**Application Number:** RC230019

**Proposed Activity:** Establishment and operation of a resource recovery park

**Applicant:** Waste Management NZ

Thank you for your s92 request for 30 Benmore Crescent, Manor Park, Lower Hutt. Please find below the responses to requests for further information made between 1 March 2023 and 11 May 2023. Documents and plans referred to are provided via a OneDrive digital link.

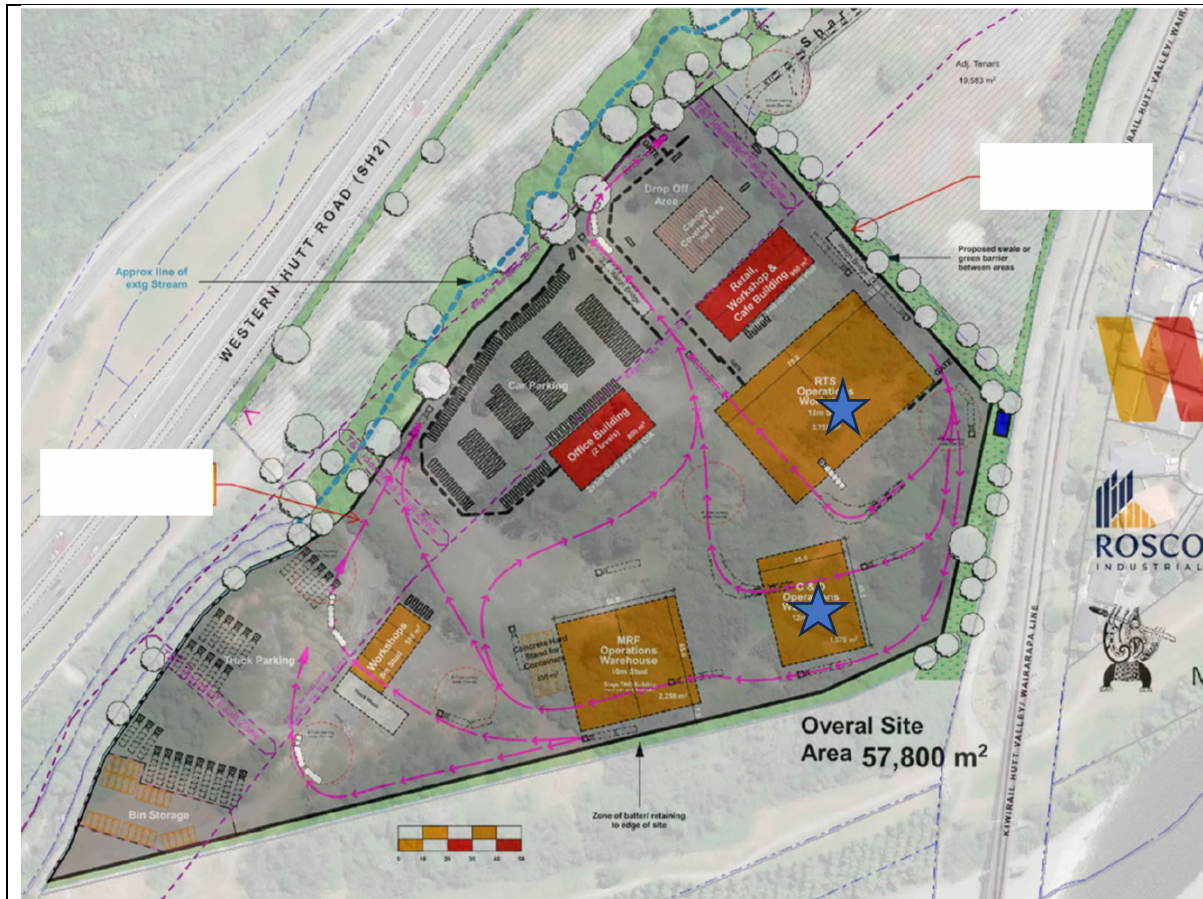
*During the meeting, you confirmed that the proposal could be a 24-hour operation with only staff movement during the night. Please confirm if this is correct and; if so, please include the approximate level of activity during these hours; e.g. anticipated number of vehicle movements.*

Waste Management provides municipal collections and collects waste from private clients. At times, a small number of drivers may leave between 5:00am to 6:00am to get an early start on their run, depending on the collection location. The drivers are on site to collect trucks only and will then leave the site. Between 5:00am to 6:00am, there are expected to be three trucks leaving the site. Between 6:00am and 7:00am, 12 trucks are expected to leave the site; though this will only occur during weekdays. There may be up to five movements between 2:00am and 5:00am. Again, this is during weekdays only. Truck movements during these hours are proposed to be kept to the western side of the site, as set out in the acoustic assessment. These movements were considered as part of the acoustic assessment that concludes noise levels stated in the District Plan are able to be met. It is noted that all the movements during these hours will be to the motorway (State Highway 2). The lighting during these times will be sensor lights only; with no lights permanently turned on during the night time period. The route taken prior to 7:00am is set out below, shown approximately by the orange highlight.
